Reading Borough Council Wensley Road : New Build & Estate Improvements Phase 1

Post-planning Design Changes Report

RBC-WLR-HTA-A_XX_XX_RP_1790

March 2022

Block C - Planing GA Plan

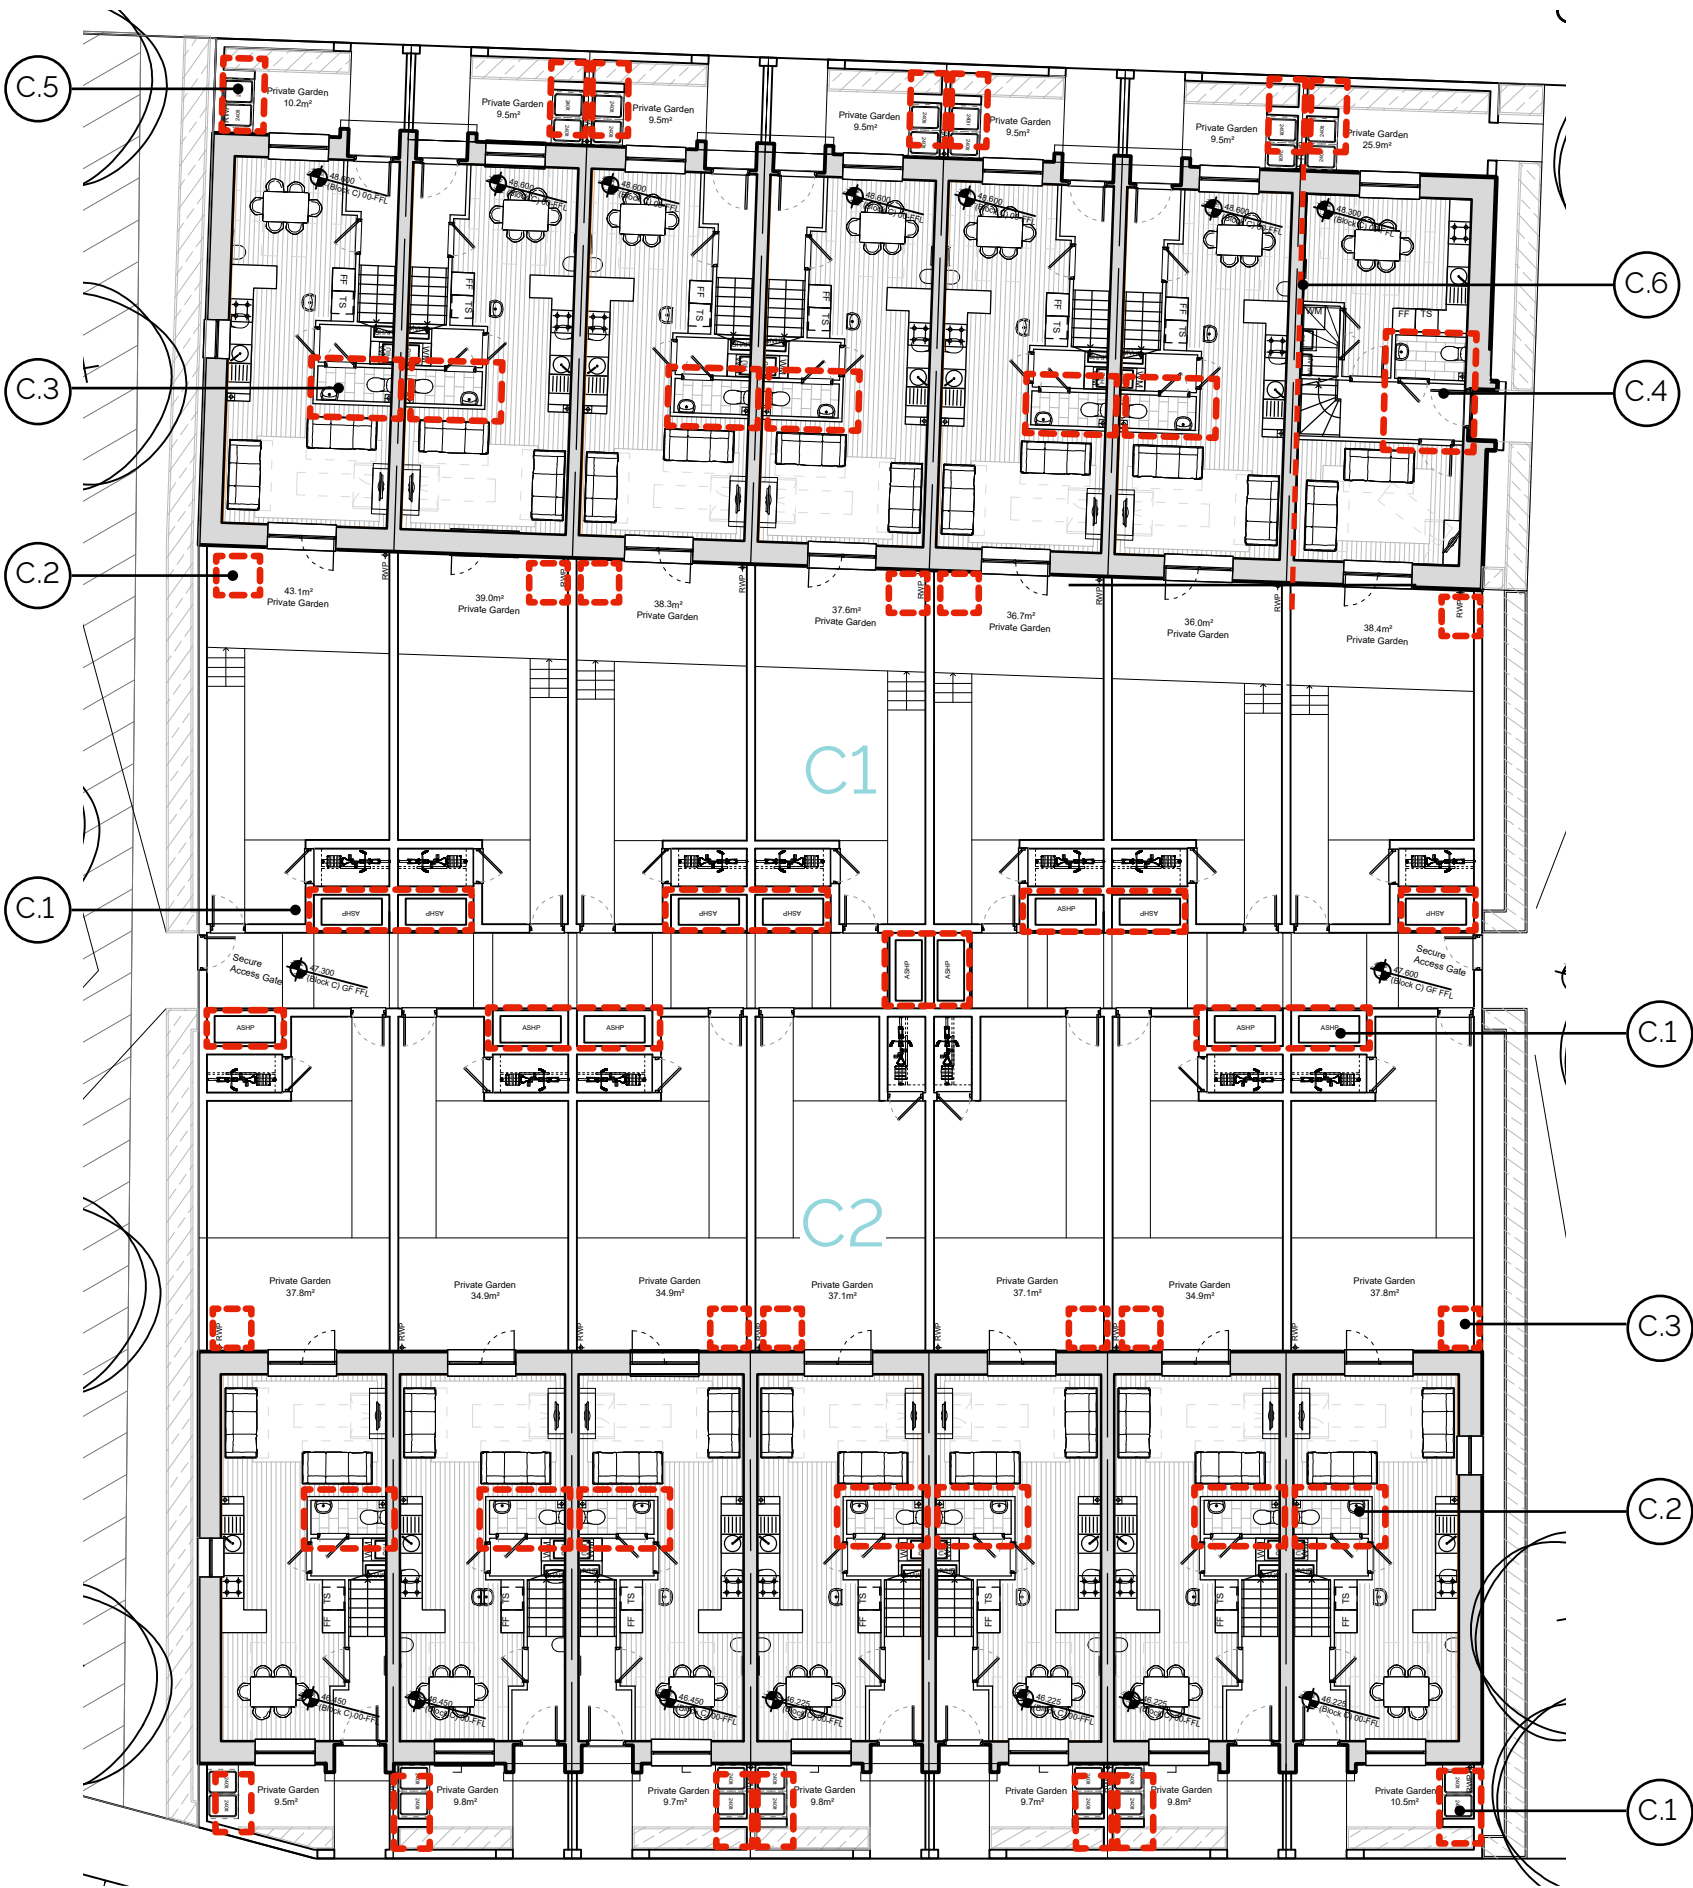
C.1	ASHP moved within the rear garden, adjacent to the houses.
C.2	Water butts and additional rainwater pipes added.
C.3	Ground floor WC increased to meet M(4).
C.4	Ground floor WC and entrance door flipped to resolve internal layout.
C.5	Material of individual refuse stores changed from brick to perforated metal.
C.6	Step in Ground Floor FFL omitted.
C.7	Minor Amendments to parapet and ridge heights.
C.8	Satellite dishes added

Block C - Current GA Plan

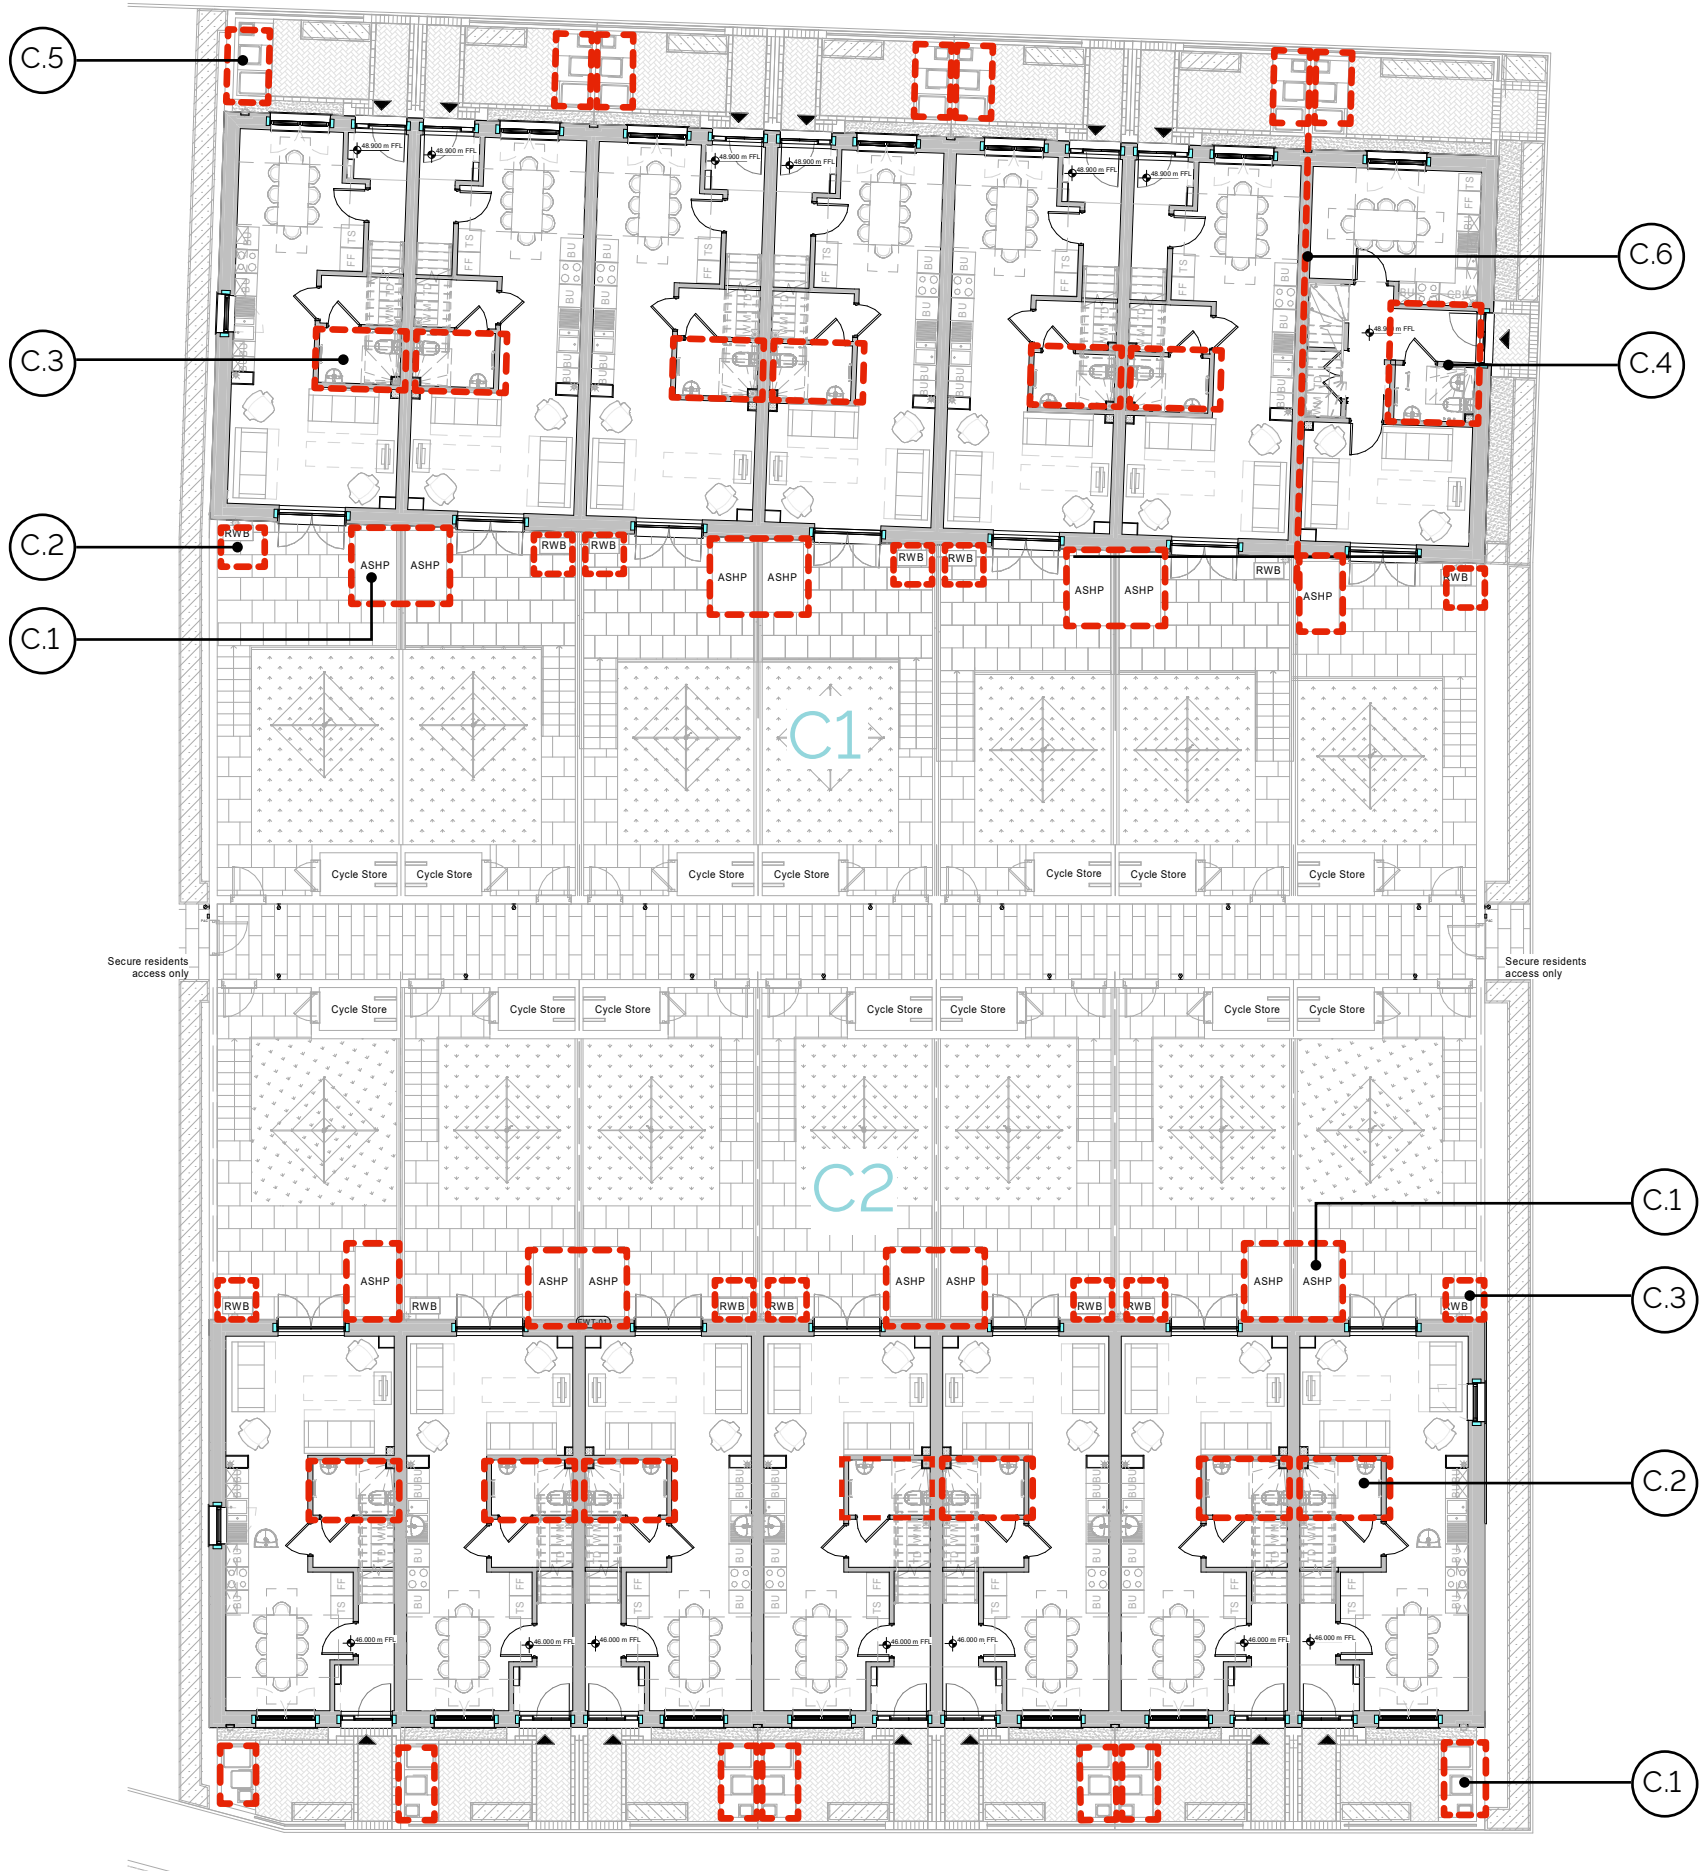
C.1	ASHP moved within the rear garden, adjacent to the houses.
C.2	Water butts and additional rainwater pipes added.
C.3	Ground floor WC increased to meet M(4).
C.4	Ground floor WC and entrance door flipped to resolve internal layout.
C.5	Material of individual refuse stores changed from brick to perforated metal.
C.6	Step in Ground Floor FFL omitted.
C.7	Minor Amendments to parapet and ridge heights.
C.8	Satellite dishes added

Block C1 South Elevation - Planning

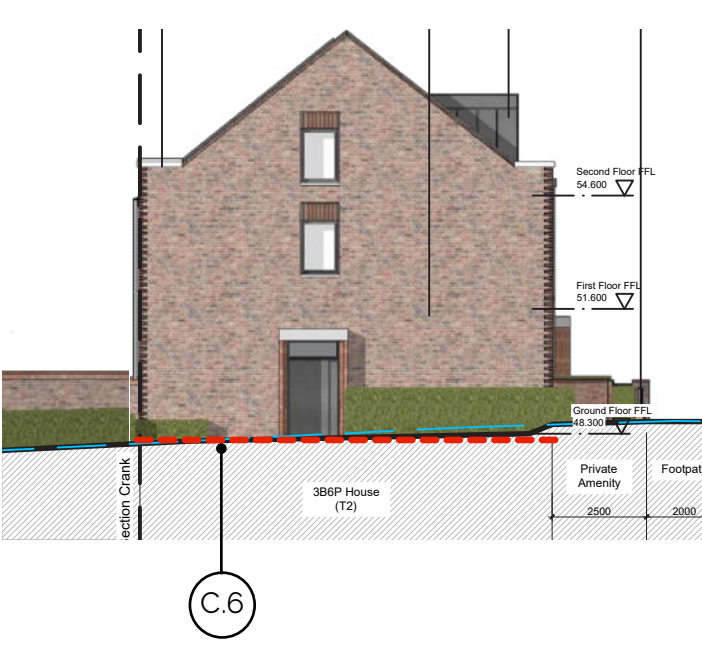
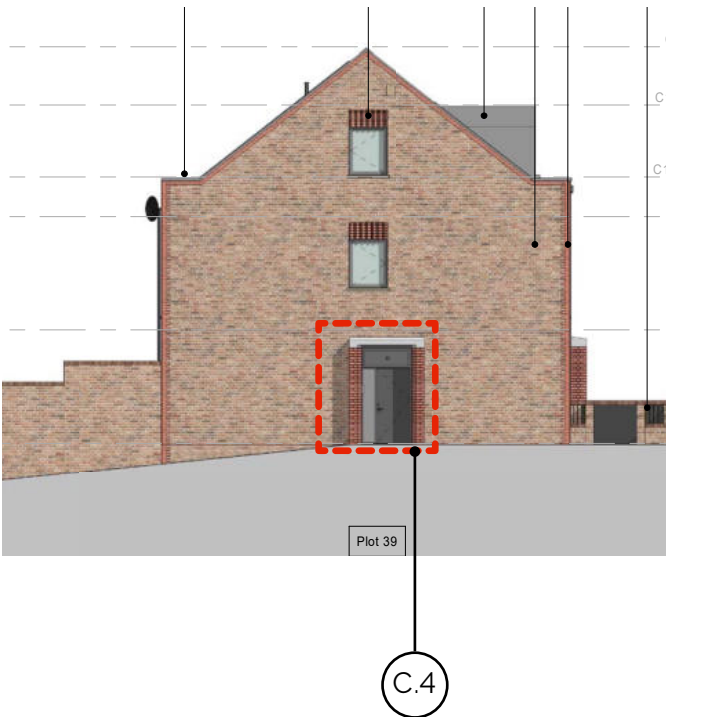
C.1	ASHP moved within the rear garden, adjacent to the houses.
C.2	Water butts and additional rainwater pipes added.
C.3	Ground floor WC increased to meet M(4).
C.4	Ground floor WC and entrance door flipped to resolve internal layout.
C.5	Material of individual refuse stores changed from brick to perforated metal.
C.6	Step in Ground Floor FFL omitted.
C.7	Minor Amendments to parapet and ridge heights.
C.8	Satellite dishes added
